REVISION TO:  
MASTER DEVELOPMENT  
DRAINAGE PLAN  
MERIDIAN RANCH  
EL PASO COUNTY, COLORADO

June 2017

Prepared By:  
Tech Contractors  
11886 Stapleton Drive  
Falcon, CO 80831  
719.495.7444

FIGURE 4

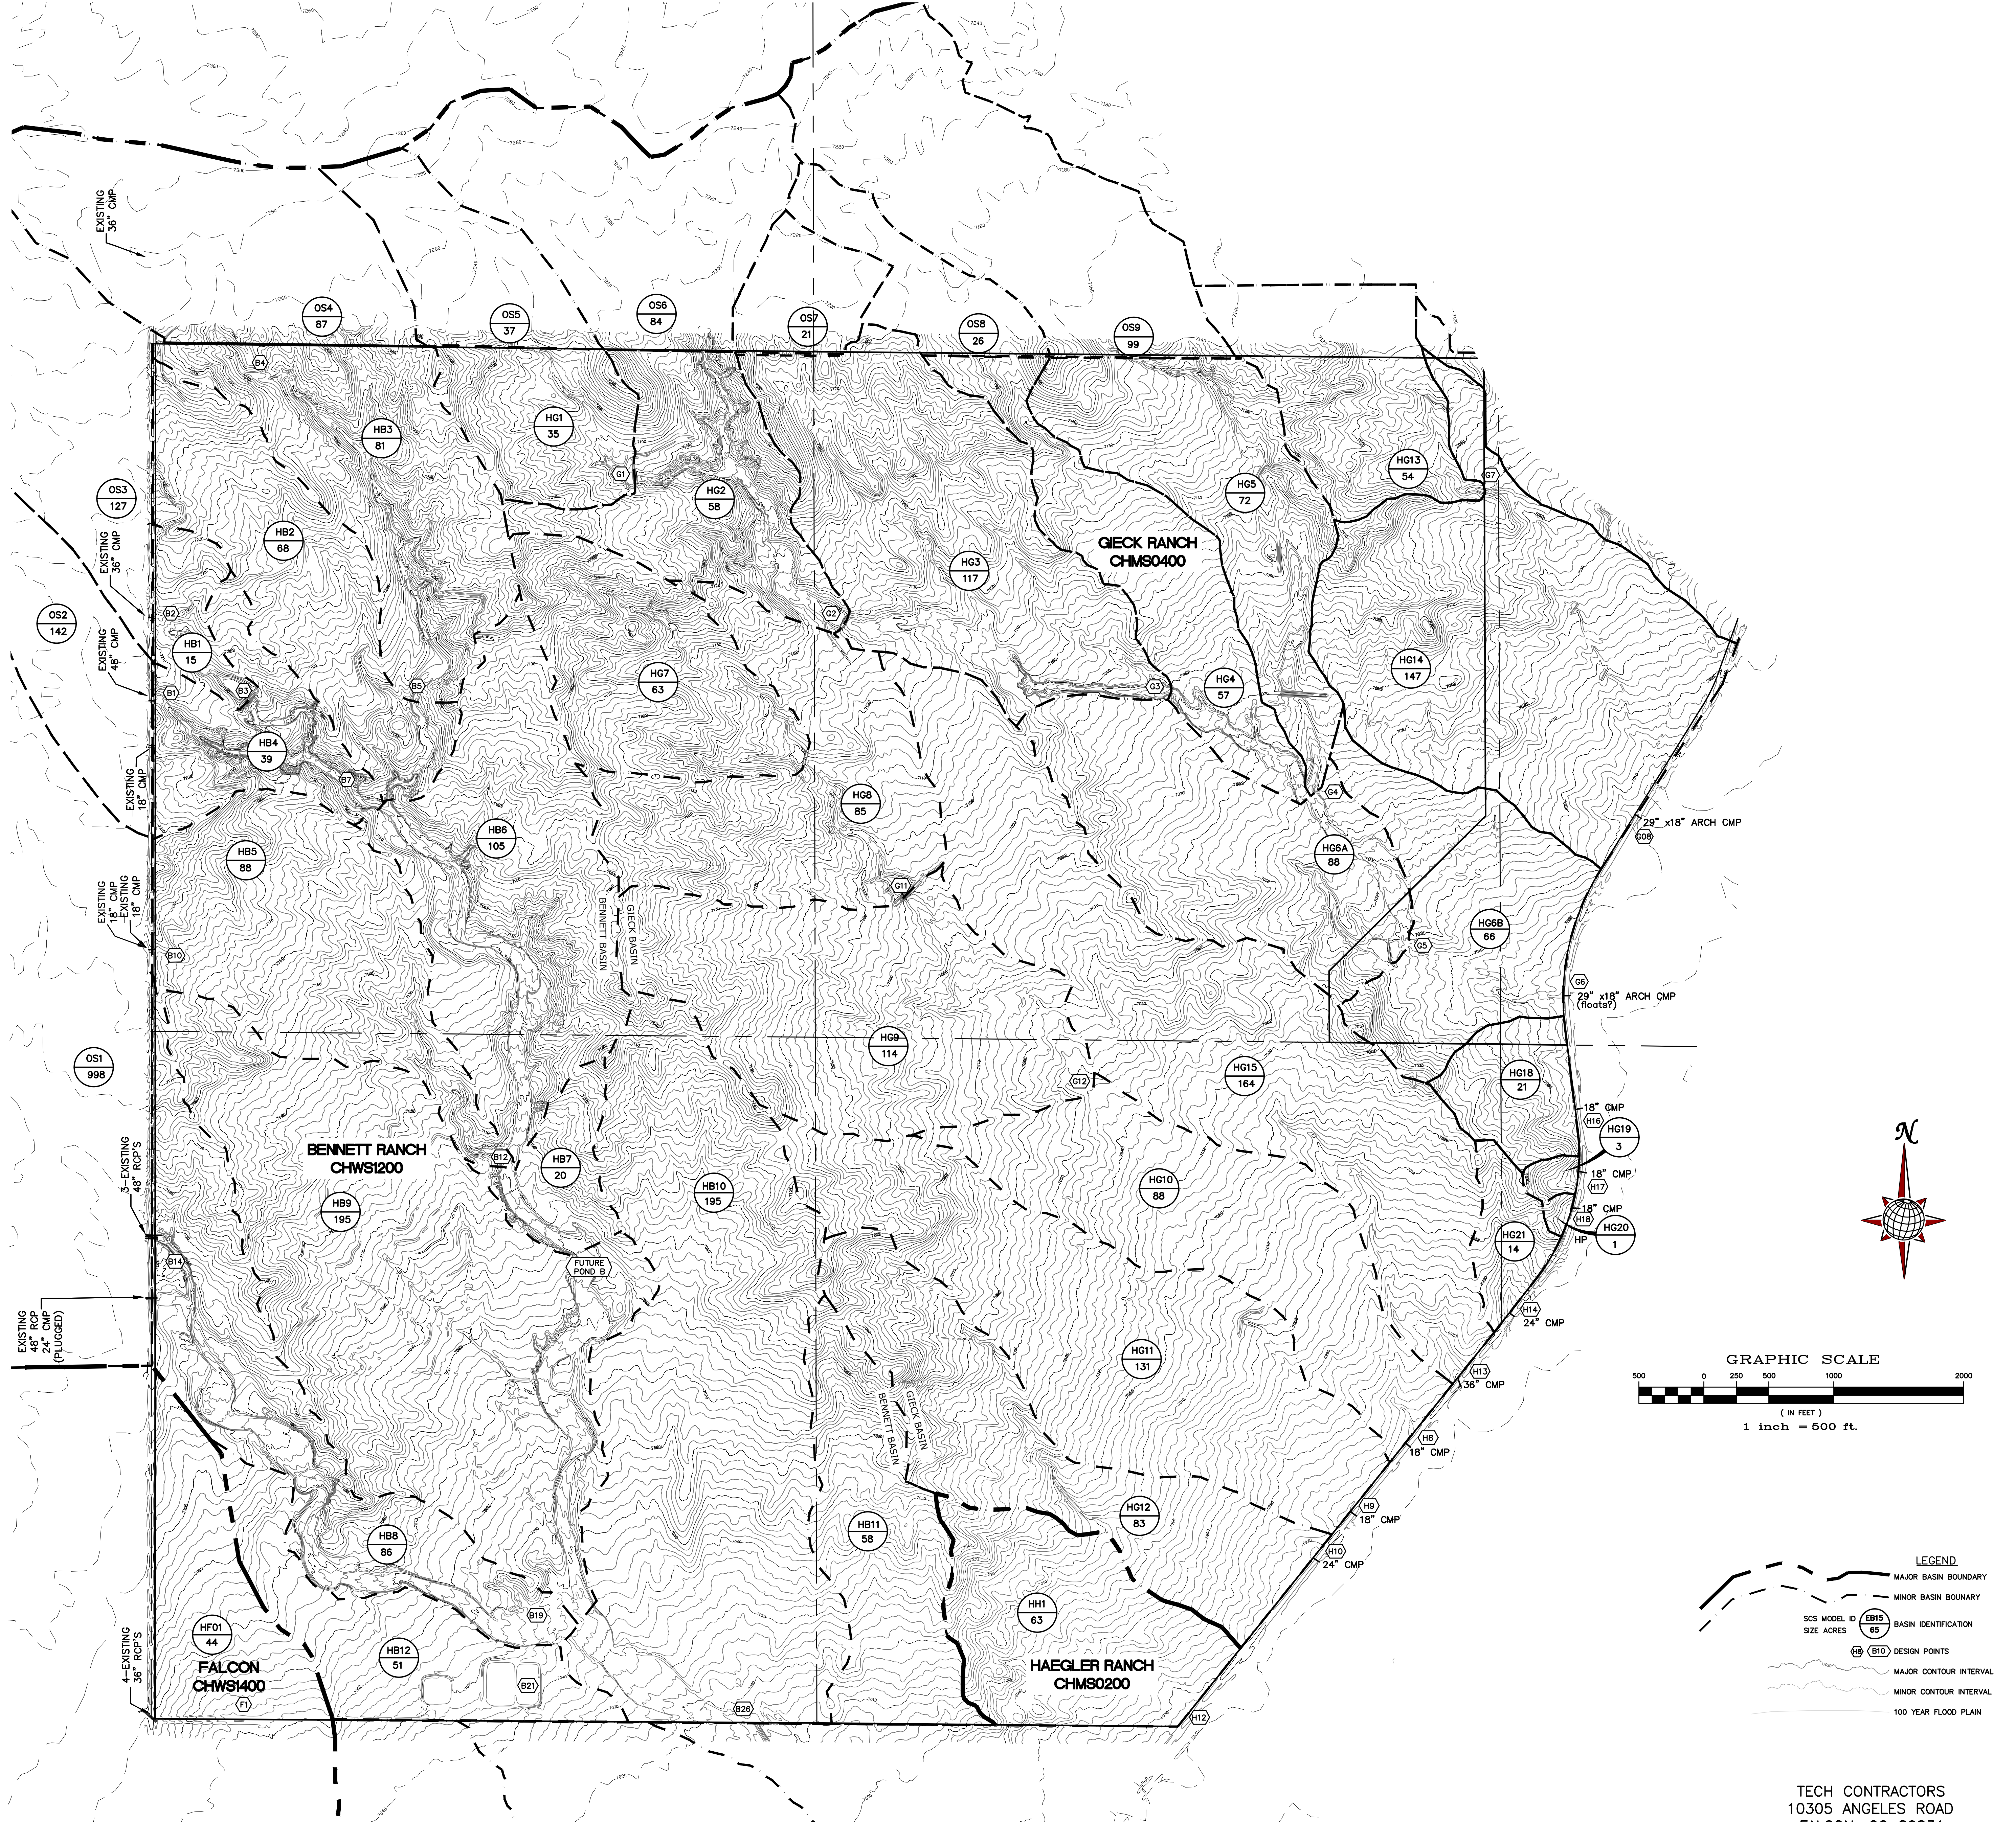
Values do not match the Drainage Map
